The Sizewell C Project

9.120 Comments on Earlier Deadlines, Subsequent Written Submissions to ISH11-14 and Comments on Responses to Change Request 19

Revision: 1.0
Applicable Regulation: Regulation 5(2)(q)
PINS Reference Number: EN010012

October 2021

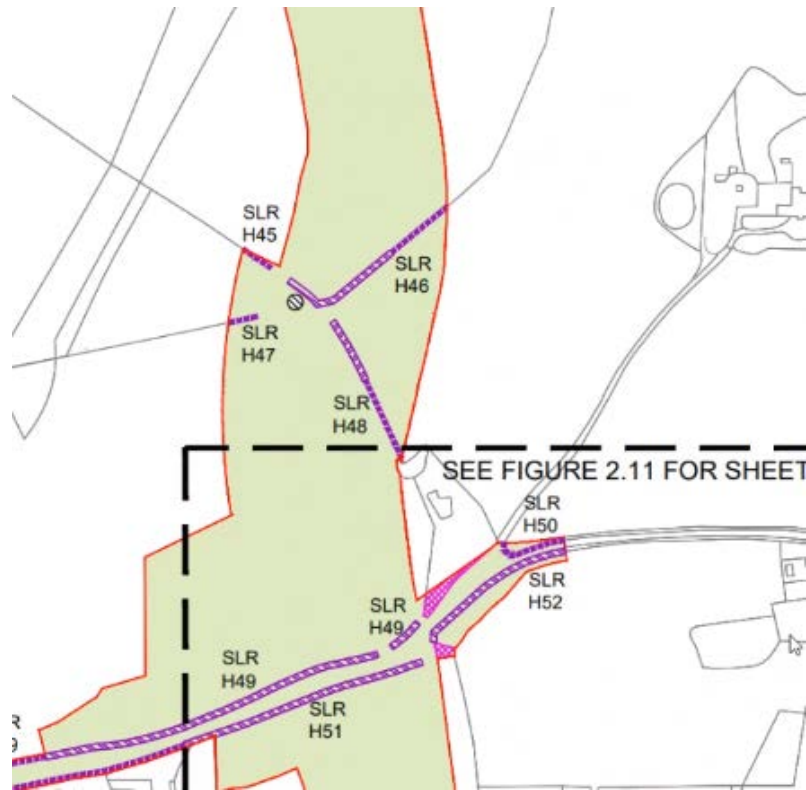
“18.5. We are concerned the failure to identify and monitor all commuting routes to be severed means the potential impact of the development on commuting bats will be underestimated and the mitigation will be inadequate. We request clarification and consideration of additional crossing point surveys at these locations.

18.6. Figure 1B shows the crossing point locations for the Sizewell link road. Crossing point surveys have not been undertaken at three hedgerows between CP20 and CP22 that will be severed by the road. We also request clarification and consideration of additional crossing point surveys at these locations.”

- 2.6.5 The locations identified were scoped into the surveys based upon: a) severance of linear features caused by the proposed route; b) where it was considered that mitigation could be incorporated based on the data collected. The purpose of the surveys was not to inform an updated impact assessment, but to inform detailed mitigation design. The data has and will continue to address the type/parameters of the mitigation which will be required to compensate for the loss/severance of such linear features. In the examples given (18.5 and 18.6), due to the required vegetation removal and the orientation of the hedgerow in relation to the road schemes, and additional main works proposed (at the main development site), mitigation in the form of hop-overs etc for the severance in this location is not possible.

Figure A.1 – Barrier (Noise) Location Plan

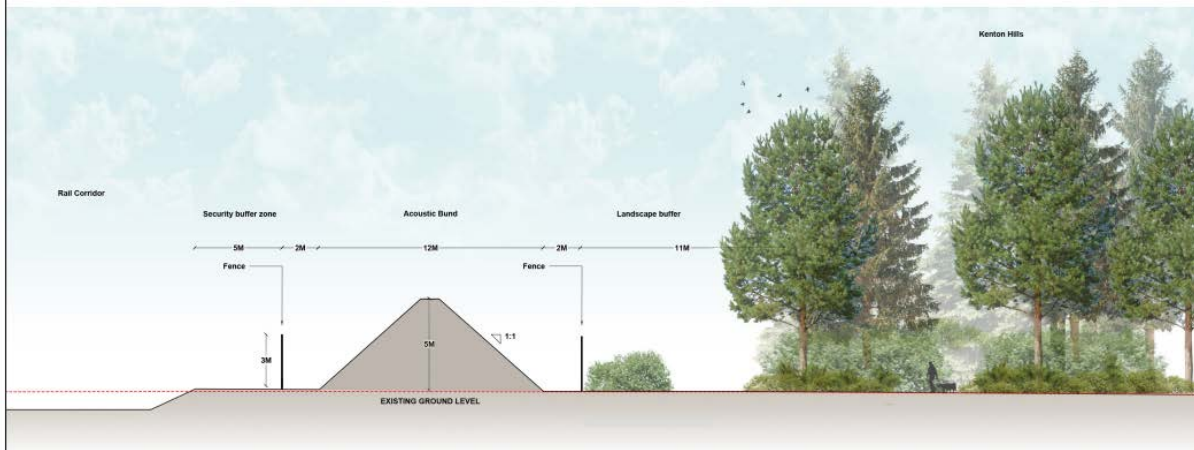
8.1. It is concerning there appears to be no screening along the northern edge of Kenton Hills and Nursery Covert, despite proximity of barbastelle roosts and foraging/commuting and the noise (and light) spill into these areas. Whilst accepting a 5m screen will never mitigate all impacts we would expect some screening in these locations. It is possible the Applicant believes the proposed earth bund will act as the screen. If this is the case, this needs to be made clear and justified. Again, the same point applies with reference to the relative height: barbastelle roost, commute and forage above 5m and hence there is expected to be considerable residual effect despite screening that does not appear to have been accounted for.”

2.6.39 The 5m bund (12m in width) does represent a screen and will provide a high level of light, visual and noise screening to adjacent woodland areas. Please see the indicative cross section provided below which is Section G of the Construction Masterplan Indicative Sections [<https://infrastructure.planninginspectorate.gov.uk/wp-content/ipc/uploads/projects/EN010012/EN010012-005395-D3%20-%20The%20Sizewell%20C%20Project%20-%20Other%20-%20Main%20Development%20Site%20Description%20of%20Constructio%20n%20Appendices%203A-3D.pdf#page=28>]. The cross section shown below also shows two 3m high fences and security and additional landscape buffers. The distance between the edge of the rail corridor and Kenton Hills is 32m in this indicative cross section.

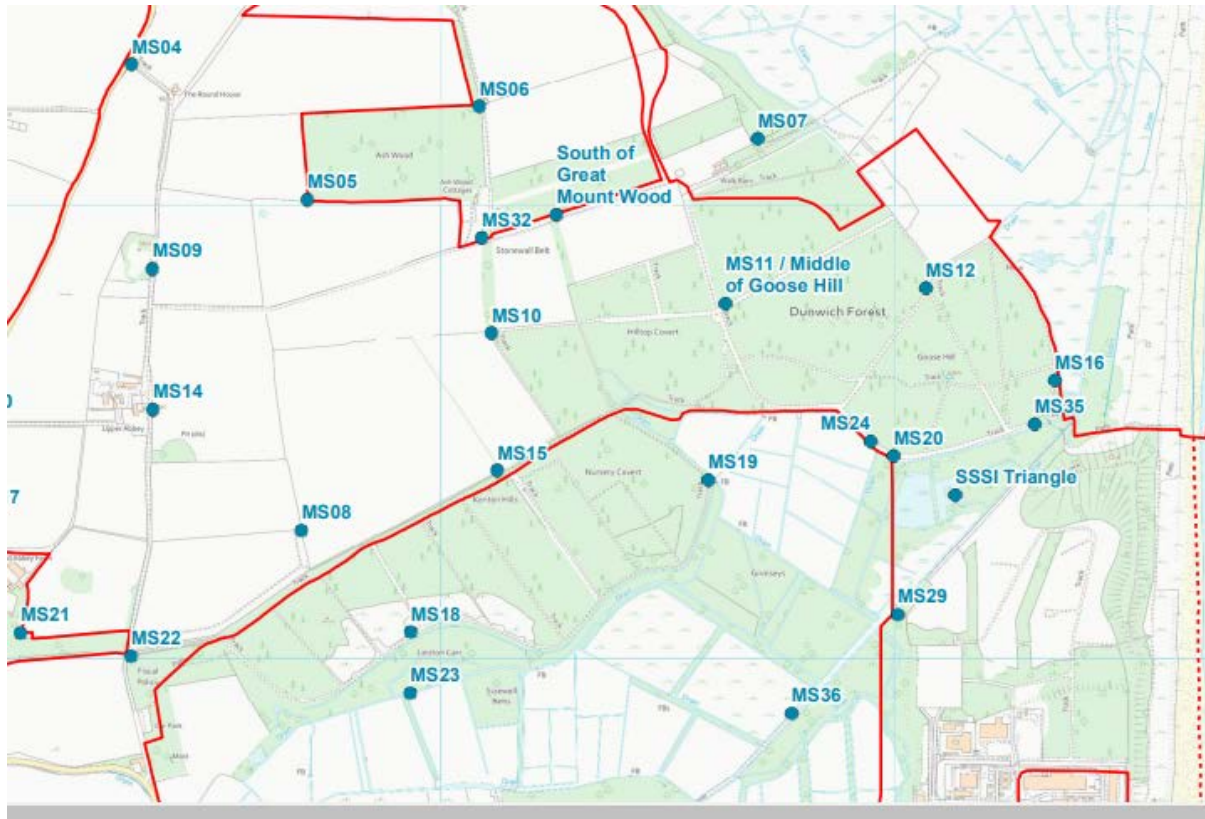
8.2. *It appears the plan has been primarily driven by anthropogenic led concerns. We question why there is no monitoring for and adjacent to key areas such as Kenton Hills, southern end of Bridleway 19, around much of Ash Wood, nor at the SSSI crossing.”*

2.6.40 SZC Co. can confirm that monitoring is proposed in these locations, as show on the figure extract below (taken from Appendix 1 of the **TEMMP**).
